Project	IEEE 802.16 Broadband Wireless Access Working Group < http://ieee802.org/16 >	
Title	Problem in Interleaver and Permutation Combination in OFDMA	
Date Submitted	2005-03-10	
Source(s)	Ayelet Doron	Ayelet.Doron@intel.com
	Yuval Lomnitz	Yuval.Lomnitz@intel.com
	Uri Perlmutter	Uri.PerlMutter@intel.com
	Eyal Bick	Eyal.Bick@intel.com
	Dov Andelman	Dov.Andelman@intel.com
	Intel.	
Re:	IEEE P802.16-2004/Cor1-D1	
Abstract	Correct the misfortunate combination of interleaver and permutation	
Purpose	Adopt changes	
Notice	This document has been prepared to assist IEEE 802.16. It is offered as a basis for discussion and is not binding on the contributing individual(s) or organization(s). The material in this document is subject to change in form and content after further study. The contributor(s) reserve(s) the right to add, amend or withdraw material contained herein.	
Release	The contributor grants a free, irrevocable license to the IEEE to incorporate material contained in this contribution, and any modifications thereof, in the creation of an IEEE Standards publication; to copyright in the IEEE's name any IEEE Standards publication even though it may include portions of this contribu

Figure 1: Worst case scenario of permutation-interleaver combination

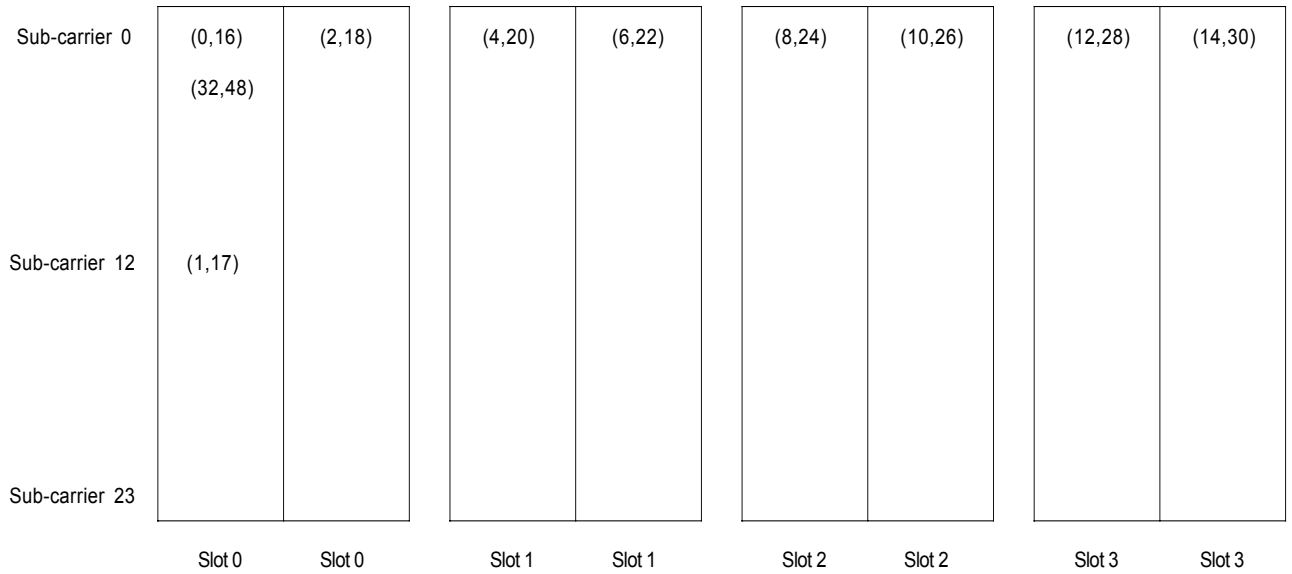
With the current interleaver dimension $d = 16$, for a worst case scenario (DL PUSC, burst allocation of 1 sub-channel, 4 slots in a FEC block, QPSK constellation) this period can be as small as 2 bits !! This example is depicted in Figure 1 where the numbers in brackets are the indices of the coded bits before the interleaver.

Figure 3: Sub-carrier reordering

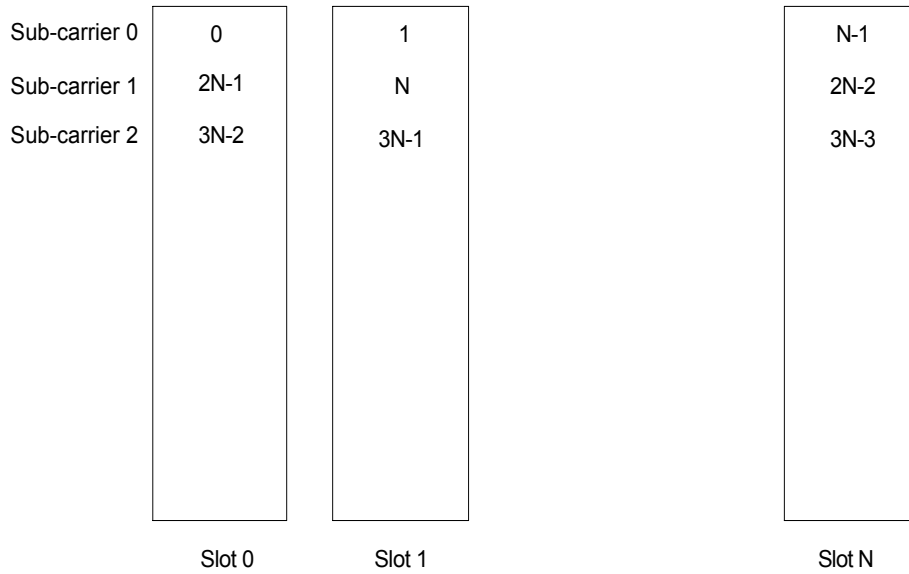
Use the same interleaver (with interleaver dimension equals 6 / 12 in the UL / DL respectively), however reorder the sub-carriers in the FEC block. The purpose of this reordering is to gather adjacent sub-carriers in frequency domain and in time domain, so that adjacent sub-carriers in the interleaver input will have significant correlation. The proposed reordering operation is depicted in Figure 2:

In order to do the reordering properly, we need to remove the in-slot rotation, for both DL and UL. Removal of the in-slot rotation requires a change in the way repetition is done. We suggest that each slot shall be rotated by $48 \cdot n/R$ subcarriers where R is the number of repetition and n is the repetition index ($0 \dots R-1$).

Figure 4: FEC block correlation after correction

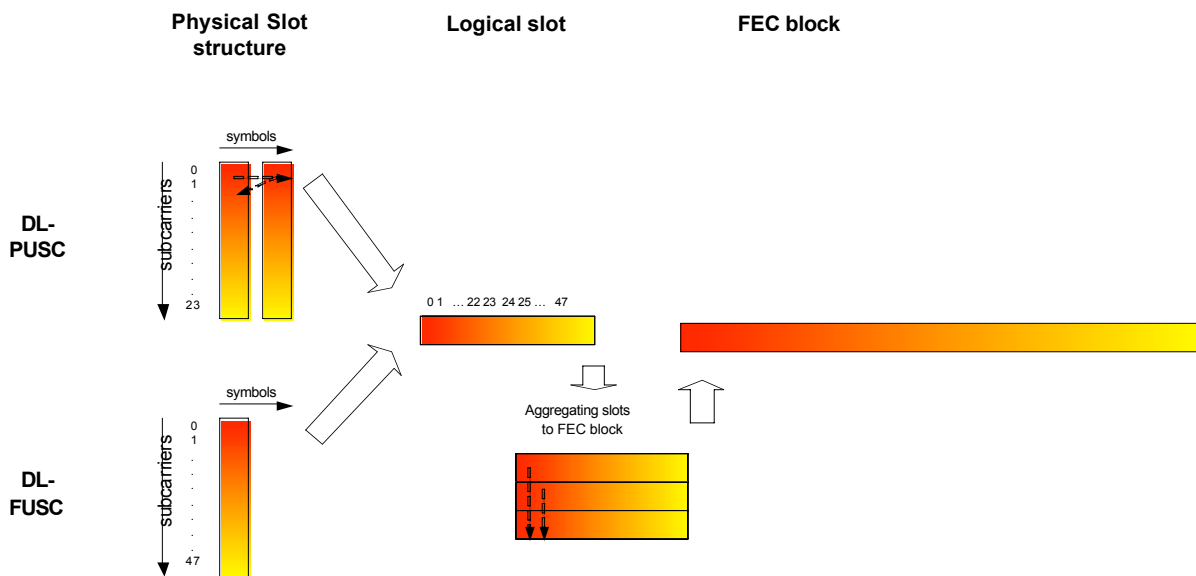
After this remedy is applied the correlation structure in a FEC block before de-interleaving will look as follows:
